Item Name: Crosstube, Low Narrow Aft, 412CF

**D412-664-245
ASSEMBLY DETAIL**

DRAWING NO. D412-664-245	TITLE CROSSTUBE ASS'Y (412 LOW-N AFT)	REV. D	DART AEROSPACE LTD ENGINEERING ORDER		D.E.O. NO. D412-664-245-D-3	SHEET NO. SHEET 1 OF 3	SCALE NTS
DRAWN 90	CHECKED J	MFG. APPR. D	APPROVED 140		DE APPR. H		
DATE 12.08.21	DATE 12.08.30	DATE 12.08.30	DATE 12.08.30		DATE 12.08.30

DRAWING NO. D412-664-245	TITLE CROSSTUBE ASS'Y (412 LOW-N AFT)	REV. D	DART AEROSPACE LTD ENGINEERING ORDER	D.E.O. NO. D412-664-245-D-3	SHEET NO. SHEET 2 OF 3	SCALE NTS
DRAWN 47	CHECKED	MFG. APPR.	APPROVED	DE APPR.		
DATE 12.08.21	DATE 12.08.27	DATE 12.08.29	DATE 12.08.29	DATE 12.08.29	DATE 12.08.29

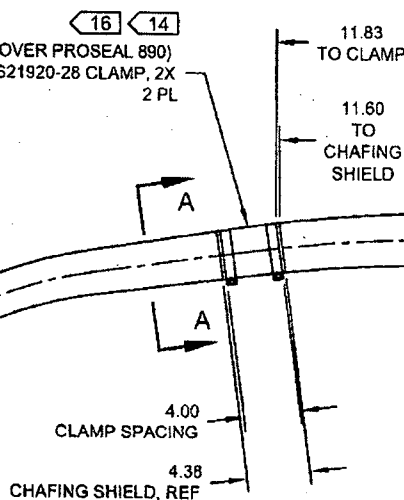
IS:

D3189-1 CHAFING SHIELD (1, INSTALLED OVER PROSEAL 890)
MS21920-28 CLAMP, 2X
2 PL

**WAS:**
